Subject: Plum Brook Reactor Facility, Supplement to Technical Specification Change  
Request, Licenses Nos. TR-3, Docket No. 50-30 and R-93, Docket No. 50-185

**Enclosure 1**  
**Description and Evaluation of the Proposed Changes**

**Revised**  
**Proposed Technical Specifications**

Technical Specifications  
Figure 1

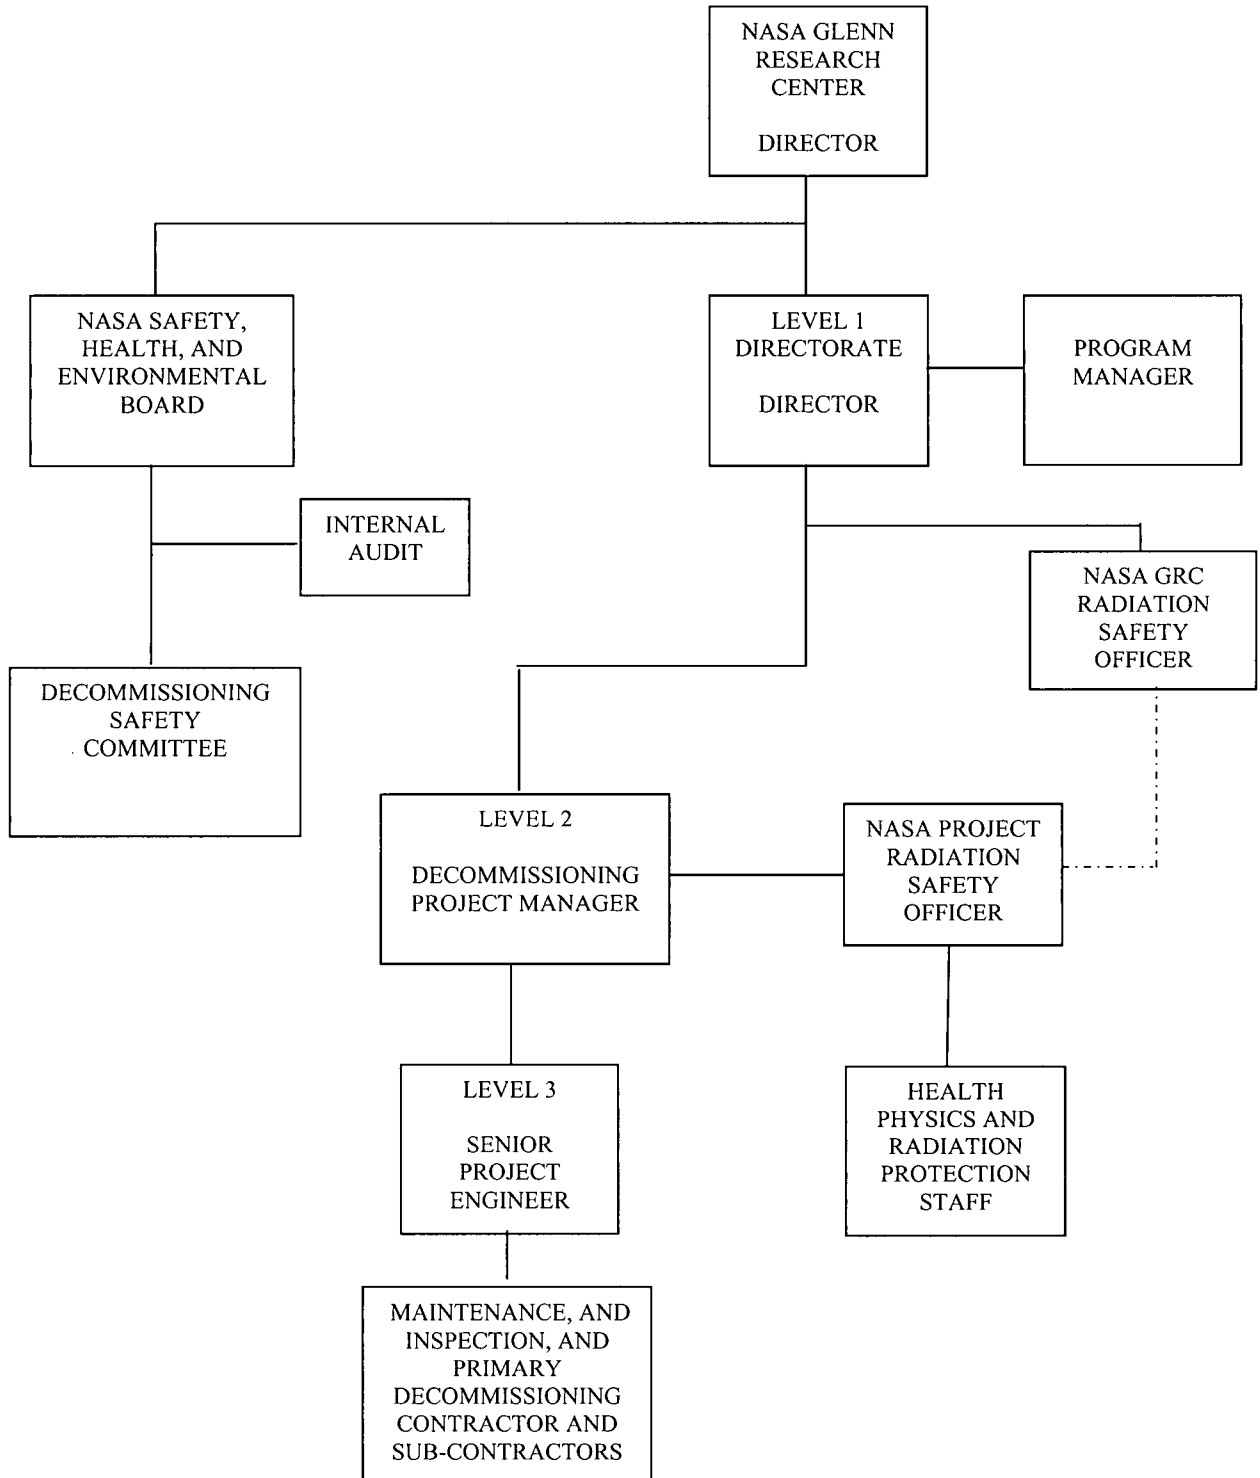
E. Figure 1 on page 24 of the proposed Technical Specifications is revised as follows:

The organization chart is revised to reflect the change in the name of the Executive Safety Board and to depict the direct reporting relationship of the Health Physics and Radiation Protection staff to the NASA Project Radiation Safety Officer.
